UNITED STATES PATENT AND TRADEMARK OFFICE

APPLICATION NO.	FILING DATE	FIRST NAMED INVENTOR	ATTORNEY DOCKET NO.	CONFIRMATION NO.
10/718,963	11/21/2003	Joseph M. Starita	3994648-129161C	4418

Office Action Summary	Application No. 10/718,963	Applicant(s) STARITA, JOSEPH M.	
	Examiner Matthew J. Daniels	Art Unit 1732

DETAILED ACTION

Left: Portion of Figure 3 from USPN 4718844 to Dickhut.

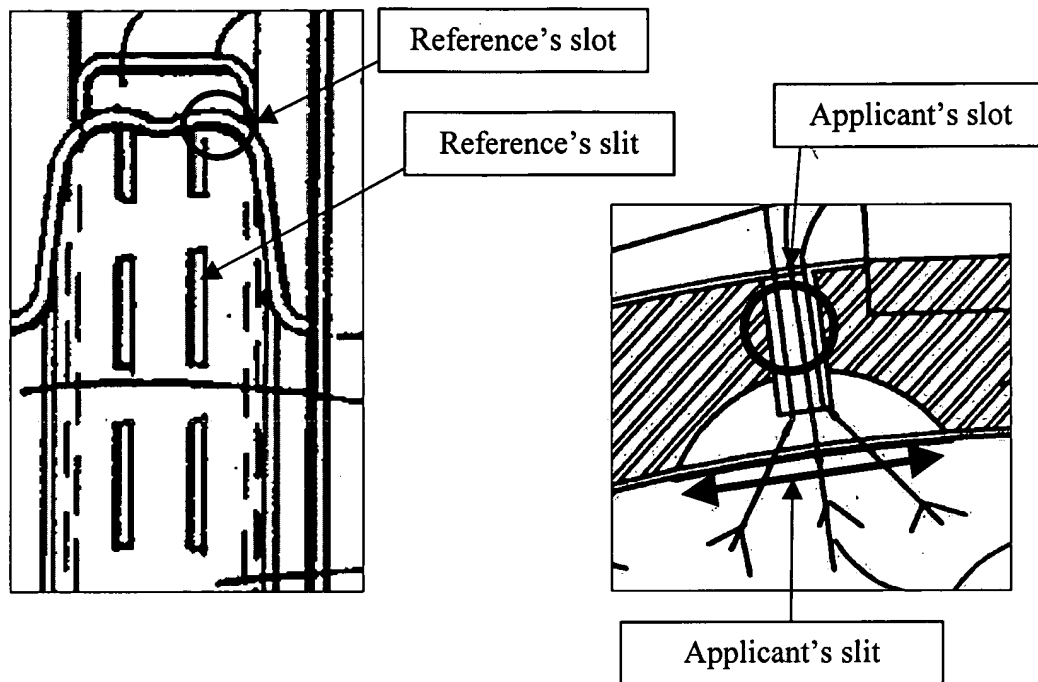
In a second interpretation, Dickhut teaches that the mold wall contains slits (Item 28 in Fig. 3), and also that the mold wall contains grooves that are interpreted to be slots. See the portions of Dickhut's Fig. 3 and Fig. 3C from the instant application.

The Examiner asserts that the in the first interpretation, Dickhut's method of delivering "uniform vacuum around the mold tunnel" (3:52-53) using substantially the same slits (Fig. 3, Item 28) as shown Item 5 in Figure 4 renders obvious the claimed method, the only difference being the configuration of the apparatus, which does not produce a materially different result or manipulative difference from Dickhut's "uniform vacuum around the mold tunnel" (3:52-53). In the alternative, Dickhut teaches portions that can be interpreted to be the same as the slits and slots of the instant application, and it would be implicit that they would fulfill the relative change in negative pressure. As to Claim 7, each of Dickhut's openings or slits has the same width (Fig. 3, Item 34 or 28). As to Claim 8, the Examiner submits that the particular pressure ratio claimed would not produce a materially different process or result than the method of Dickhut
